MIL-C-70583B (AR)
AMENDMENT 1
28 December 1992

MILITARY SPECIFICATION

CIRCUIT BOARD, ± 15-VOLT CONVERTER,
VOLTAGE CONVERTER (PIVADS): 9397384

Figure 1. Burn-in Temperature Versus Time Diagram

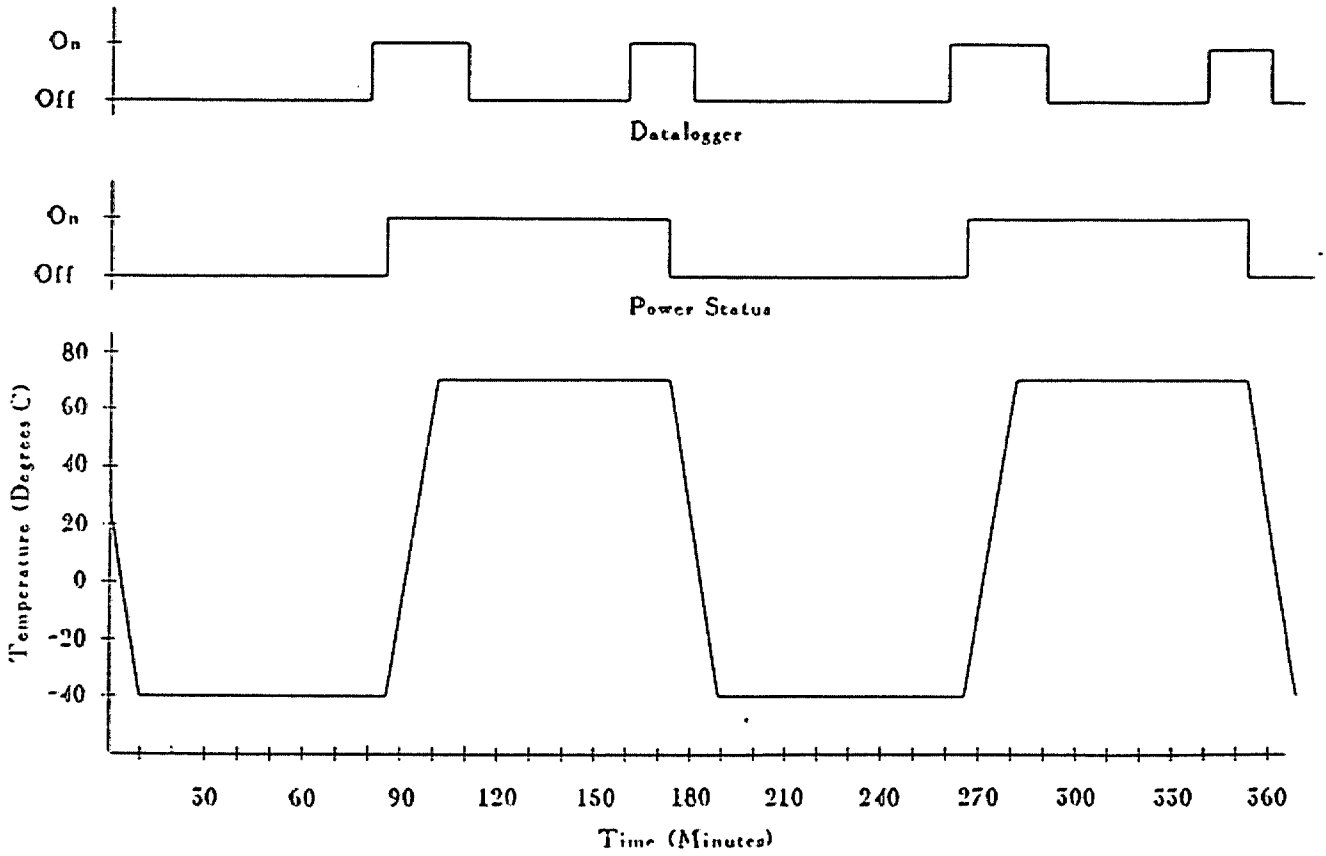
Figure 1: Delete in its entirety and substitute the following:
